11-WTP-346

CONTRACT NO. DE-AC27-01RV14136 – THE U.S. DEPARTMENT OF ENERGY, WASTE TREATMENT AND IMMOBILIZATION PLANT (DOE-WTP) SURVEILLANCE REPORT S-11-WED-RPPWTP-042; REVIEW OF PRETREATMENT FACILITY (PTF) VESSEL VENT PROCESS (PVP) SYSTEM HEADER PIPE INSTALLATION IN PLANNING AREA 7

Report Number: S-11-WED-RPPWTP-042

Title: Review of Pretreatment Facility (PTF) Vessel Vent Process (PVP) System Header Pipe Installation in Planning Area 7

Fig. 1, Model view showing installed section

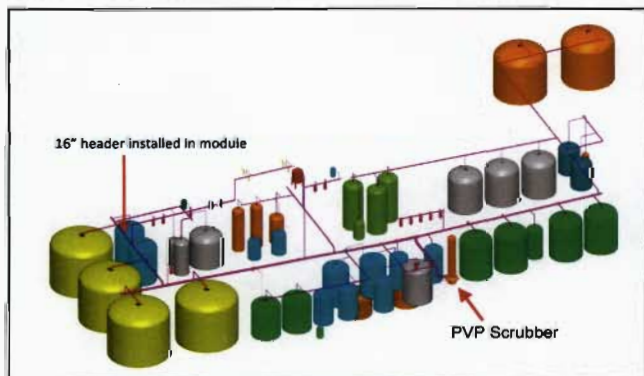
A large piping module was installed in the PTF Planning Area 7 in late July, including a section of 16" SC-I, Safety Class PTF PVP system header piping (see Figures 1 & 2 below):

The PTF PVP system pipe in Planning Area 7, as installed, supports an active safety function of the system (either case 3 or 4 from CCN: 234433). The pipe is SC-I and Safety Class. Both of the scenarios cited in CCN: 234433 assume Multiple Sparger or Pulse Jet Mixer Overblow

(MOB) controls are added. However, these controls do not yet exist in the PDSA. The need for MOB controls was identified by Bechtel National, Inc. (BNI) engineering in May 2011, including proposed controls (ref. CCN: 234424).

Without MOB controls, the PTF PVP System would need to be sized to accommodate the flow associated with MOB conditions. This may require increasing the size of the PVP header enough to nearly double the airflow (from 4000 to 7000 scfm).

The first PVP system piping module was installed in Planning Area 7 in late July. The lack of MOB controls in the AB brings into question whether this pipe was undersized.
